# Dung Duc Tran et al. Assessing impacts of dike construction on the flood dynamics in the Mekong Delta

Responses to Reviewer#1 comments

Figure 3: Time-series of simulated and observed flows in 2011 at representative stations

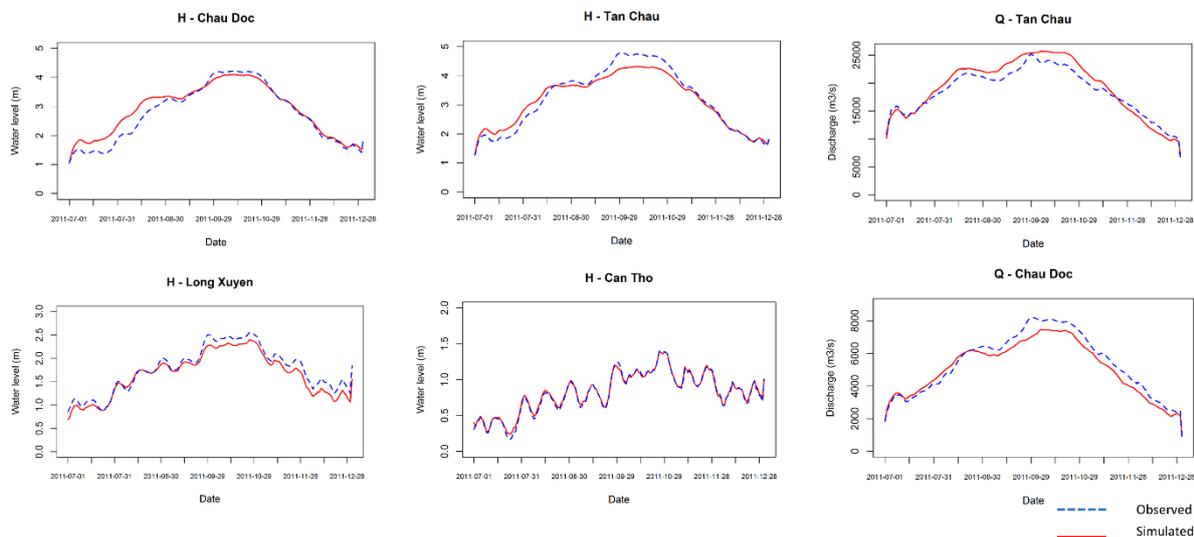
**14. Comment P14 Ln19:** I’m confused about the Q-Q plots in figure 3. What does each point represent? Are they daily simulated and observed streamflow? If yes, the authors should consider the time-series plot for the streamflow results.

**Response:** Each point in the Q-Q plot in Figure 3 represents the correlation between daily simulated and observed streamflow, based on Correlation Coefficient ( $R^2$ ) and Nash-Sutcliffe Efficiency (NSE). We agree with Reviewer#1 to present some time-series plots in the manuscript instead of the Q-Q plots. Another reason is that Table 1 already shows the NSE and  $R^2$ . All the Q-Q plots will be presented only in the Supplement. We will also add all time-series plots to the Supplement. Figure 3 will be captioned as “Time series of simulated and observed flows in 2011 at representative stations”.

Figure 4: Simulated and observed maximum water levels for the 2000, 2011 and 2013 flood years at 4 different stations along the Hau River.

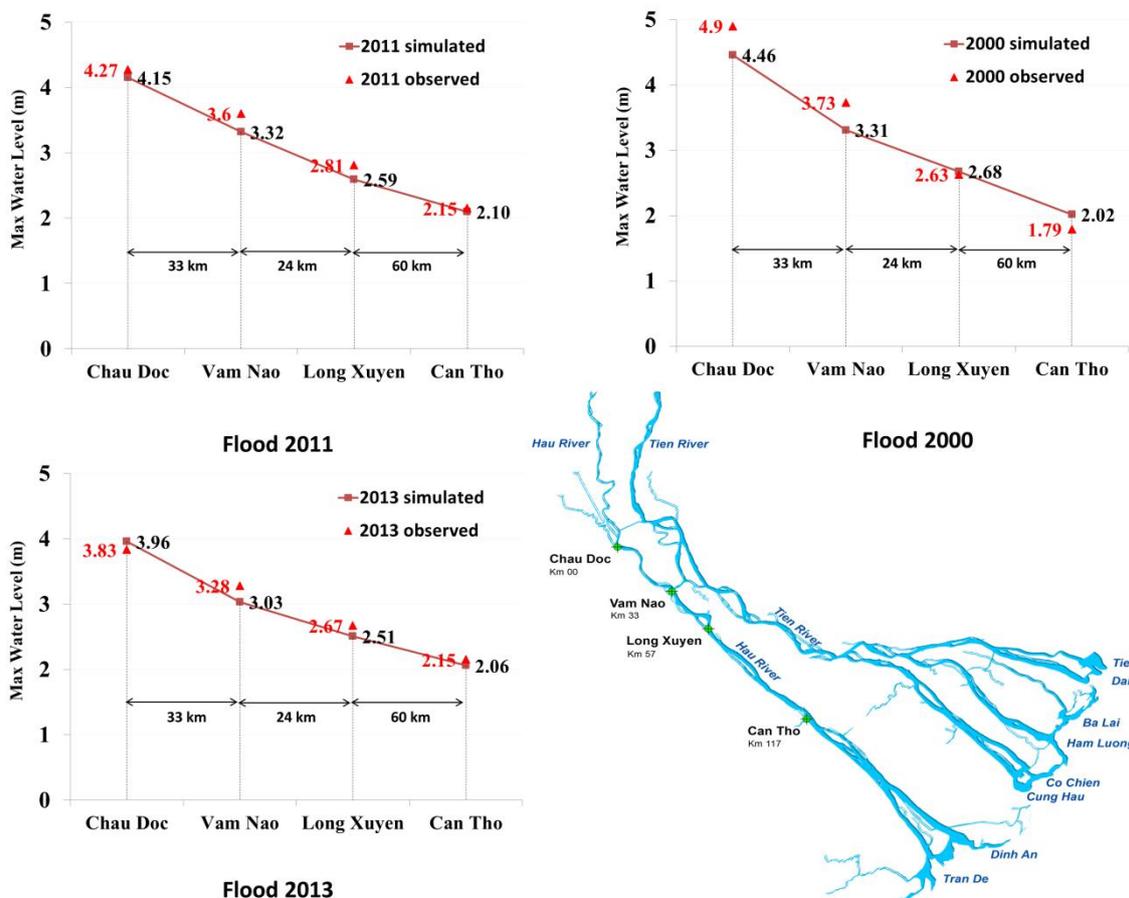
**15. Comment P15 Ln12-13:** The x-axis of figure 4 should be the distance instead of the sites. I expect the explanation of underestimated simulated streamflow to be right after the figures.

**Response:** In the submitted manuscript, we used the 4 sites instead the distance shown in the axis because these are important points measured along the Hau River. For example, Chau Doc

and Can Tho are two points we explore the difference in measured water levels between the floods of 2000 and 2011. In addition, the x-axis of Figure 4 also shows the distance of 4 sites. We will add an explanation of underestimated simulated streamflow from Figure 4 (below).

Added text right after the figure: *“The figure shows a good fitness of simulated and observed peak water levels in floods of 2011(calibration) and 2013 (validation). In the flood 2000, the fitness is low due to the significant changes in physical topography such as river cross-sections between the model setup of 2011 and the measured data in 2000.”*
